STAFF RECOMMENDATION
1613 Lillian Street
November 16, 2016

Application: New construction—detached accessory dwelling unit; Setback determination

District: Lockeland Springs-East End Neighborhood Conservation Zoning Overlay

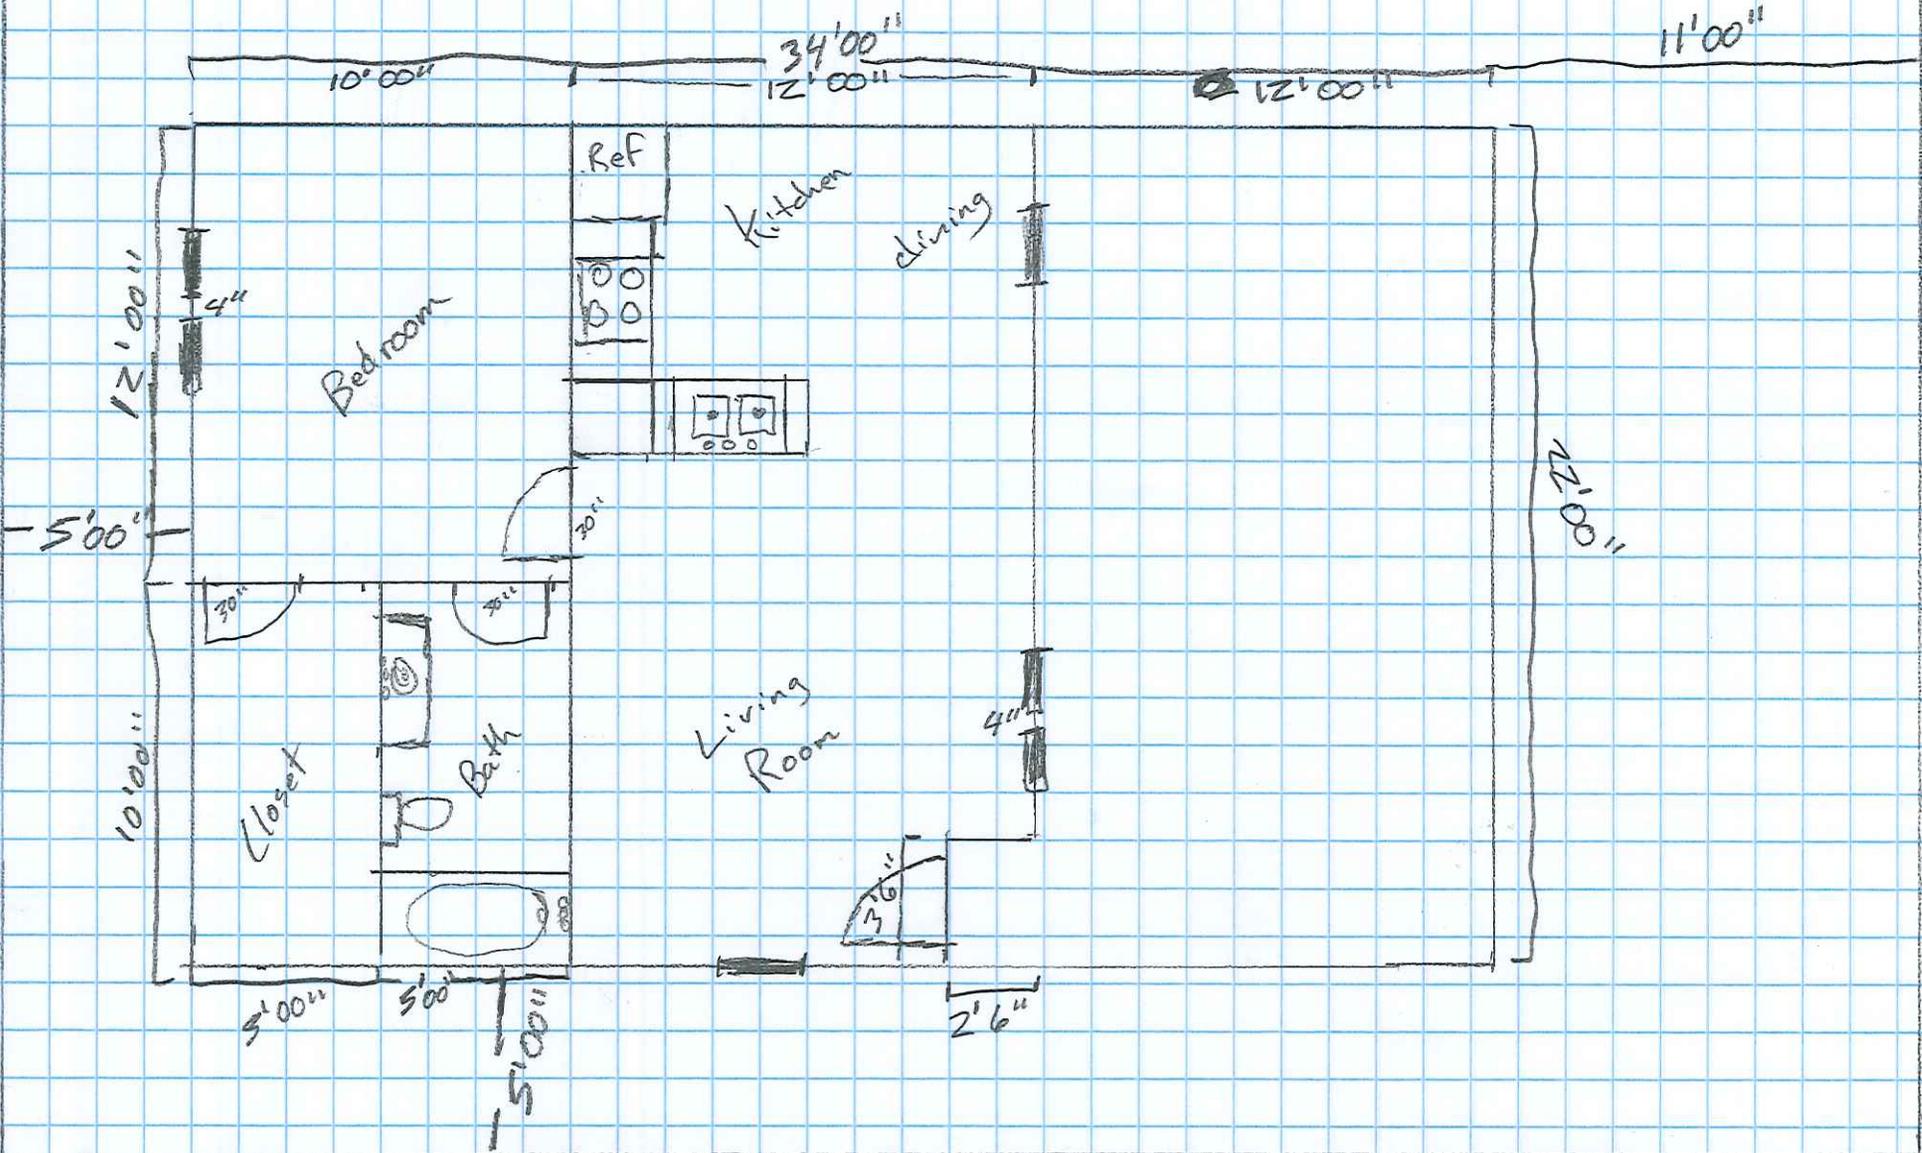
The new outbuilding does require a rear setback determination. When an outbuilding has a footprint greater than seven hundred square feet (700 sq. ft.), base zoning requires that the structure be located twenty feet (20') from the rear property line and five feet (5') from the side property lines. In this instance, the proposed outbuilding does meet the base zoning side setbacks but does not meet the twenty-foot (20') base zoning rear setback. It is proposed to be located five feet (5') from the rear property line.

Staff finds that the proposed five foot (5') rear setback is appropriate for several reasons. Historically, outbuildings were located at the rear of the property, close to the rear and side property lines. A five foot (5') rear setback is more appropriate historically than a twenty foot (20') rear setback. In addition, when a structure has a footprint of less than 700 sq. ft., a carport like this one can be as close as three feet (3') from the rear property line. Also, the five foot (5') rear setback will allow for more space in between the historic house and the outbuilding. For these reasons, staff finds the proposed setbacks to meet Section II.B.8 of the design guidelines and 17.16.30.G. 4 of the ordinance.

FRONT Elevation (Alley)
North

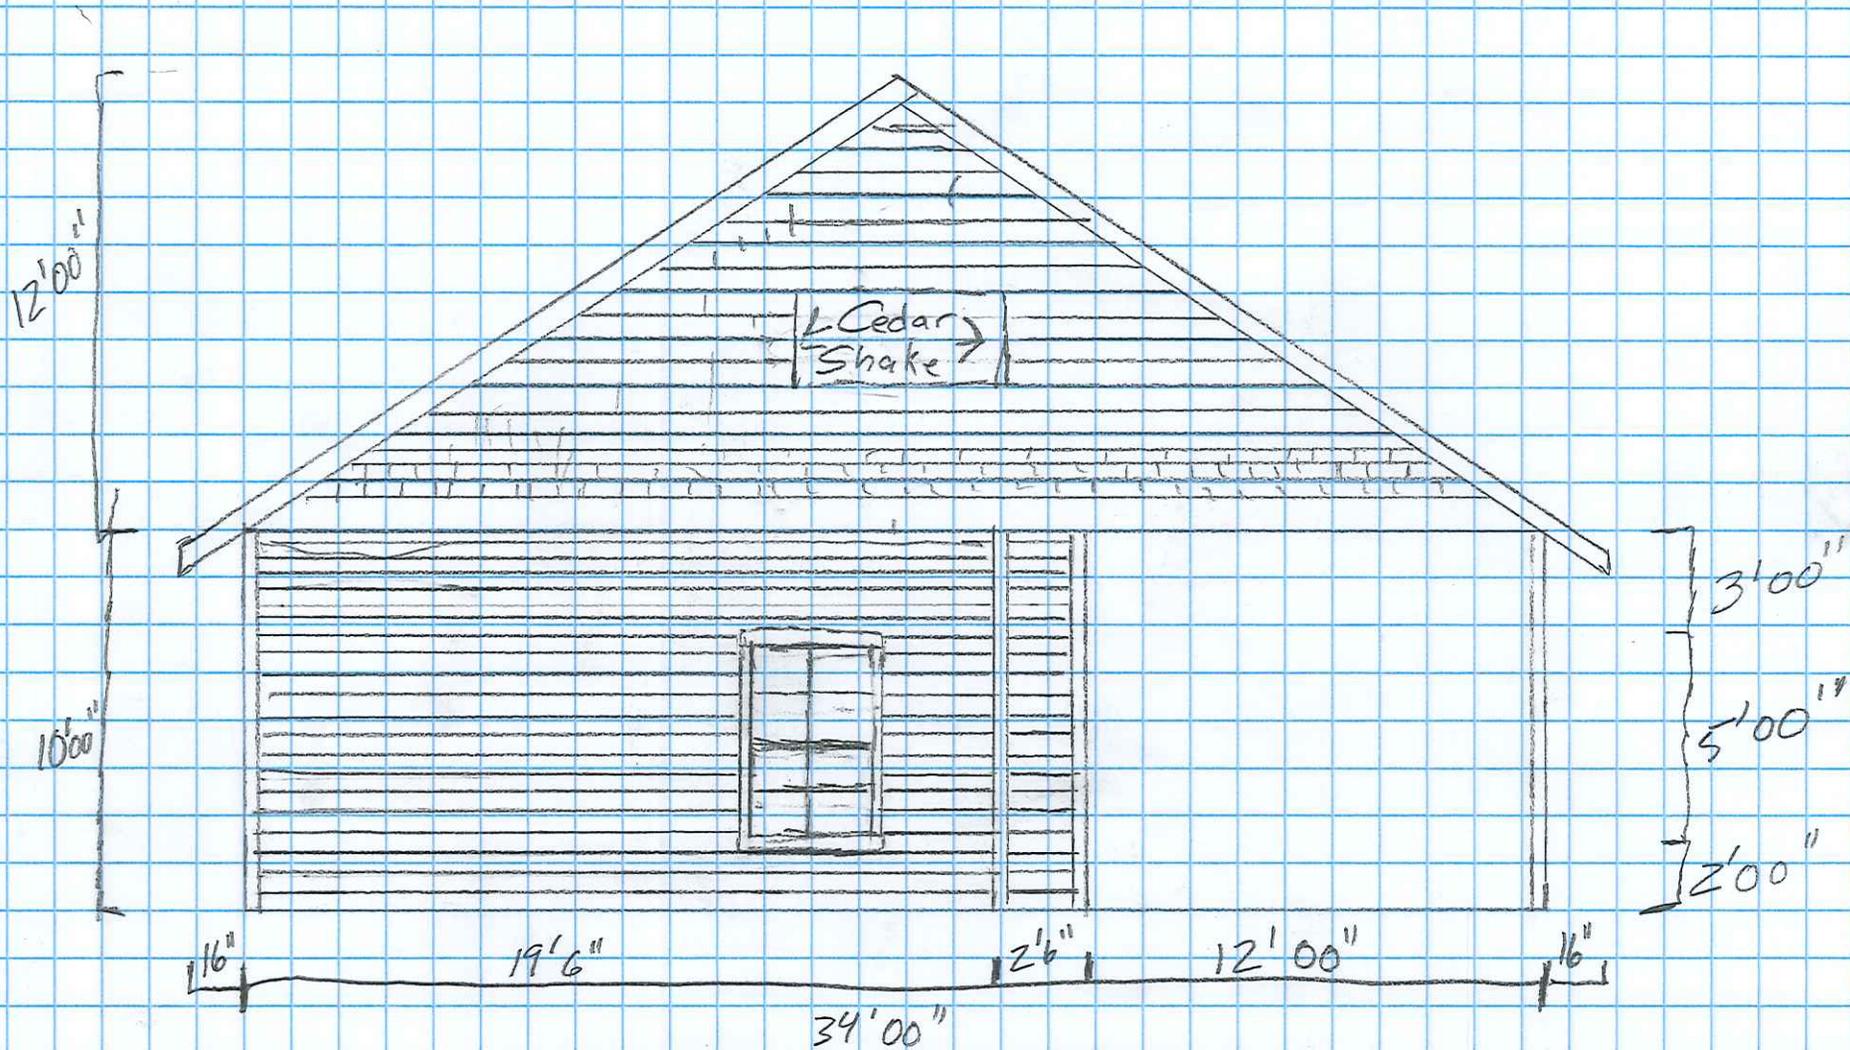
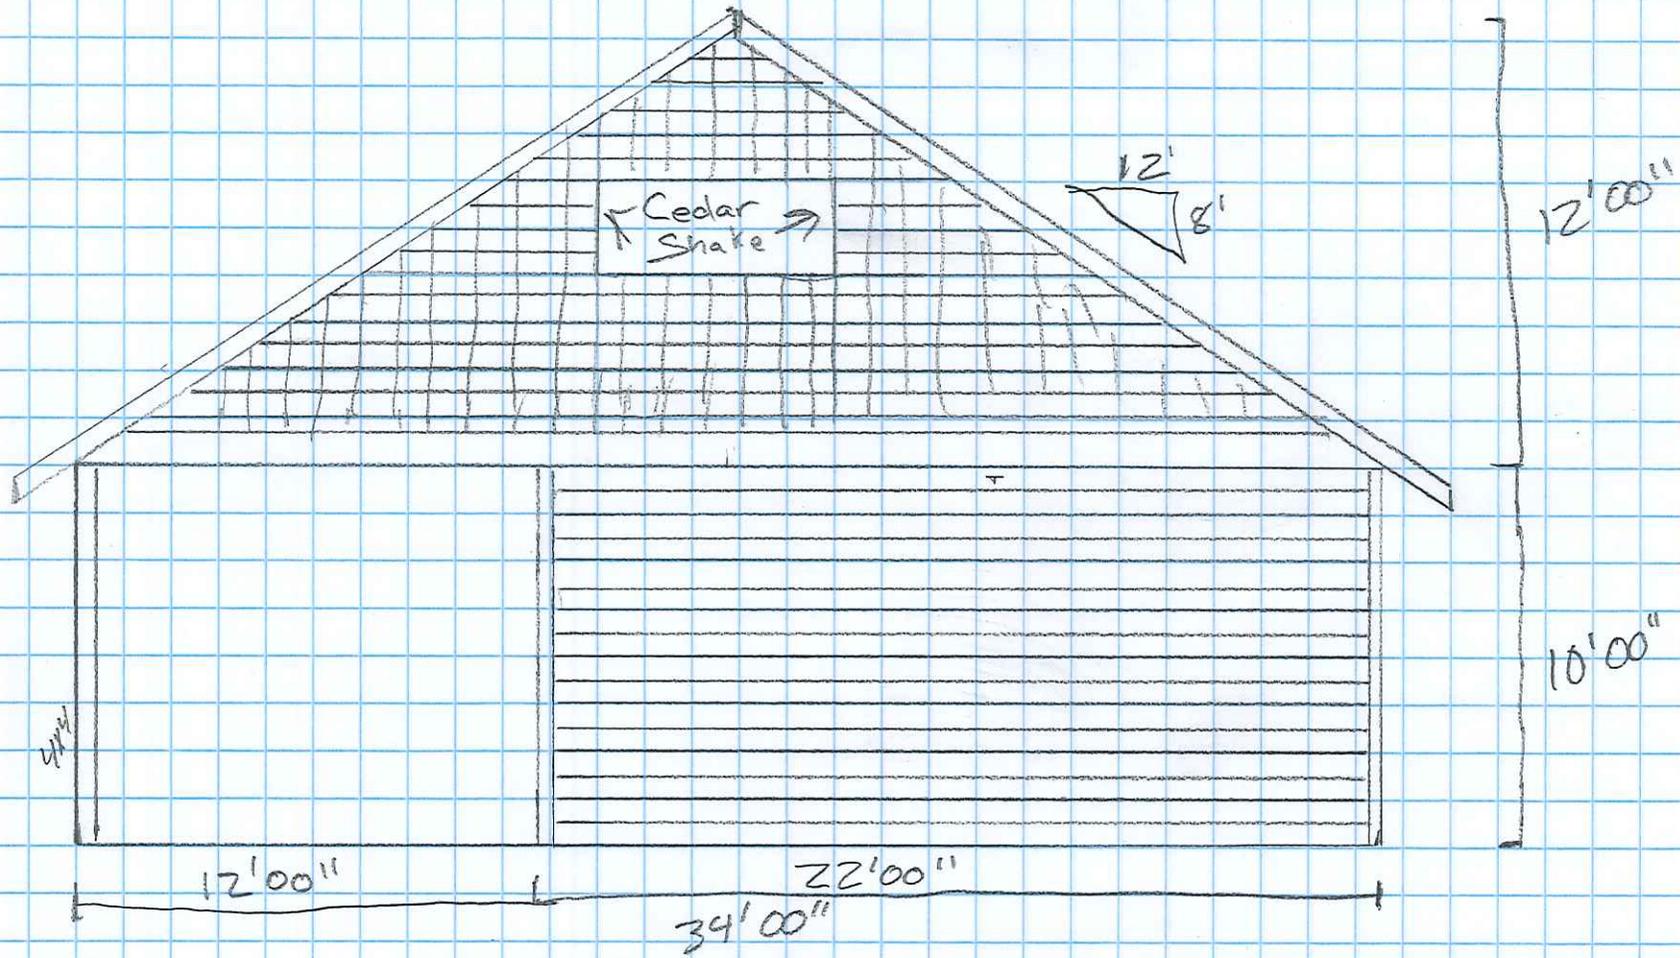
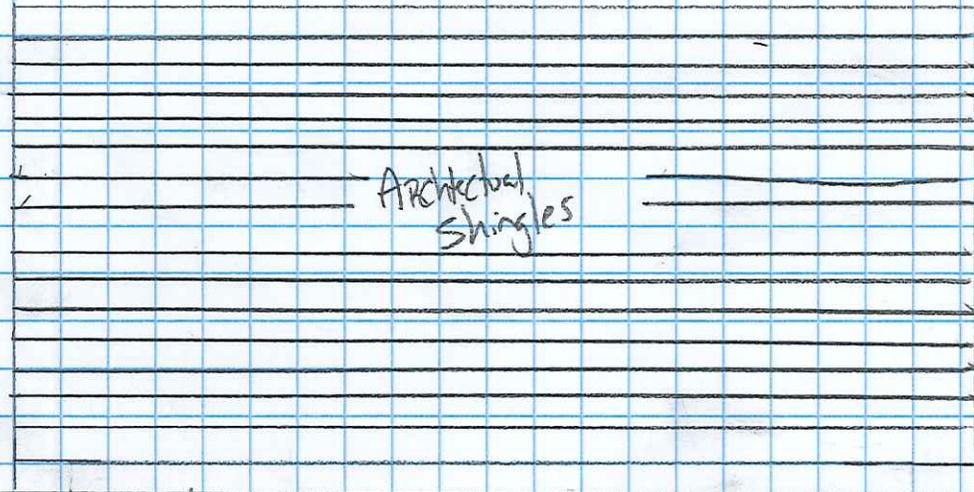
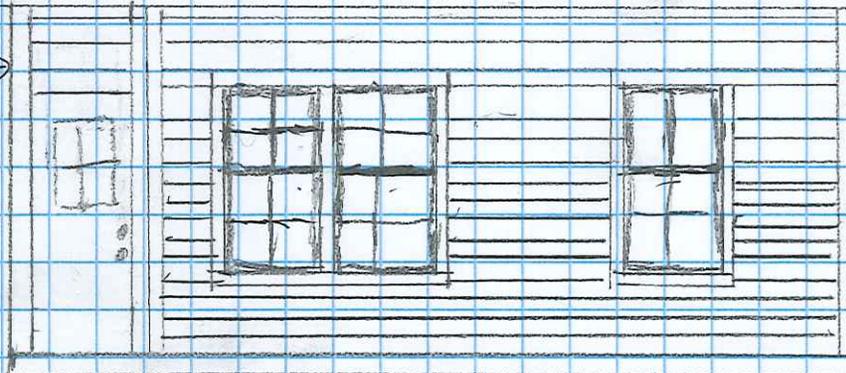
Design Standards: The accessory structure has a simple, utilitarian design that is appropriate for outbuildings. Its roof form, detailing, and form do not contrast greatly with the primary structure. The outbuilding is in a minimally-visible location at the side and rear of the primary structure. Staff finds that the design meets section II.B.8 of the design guidelines and Section 17.16.030.G.8 of the ordinance.

With the staff's final approval of the windows and the architectural shingle color, staff finds that the known materials meet Section II.B.8

1. Staff approve the final details, dimensions and materials of windows and doors prior to purchase and installation; and
2. Staff approve the roof shingle color.
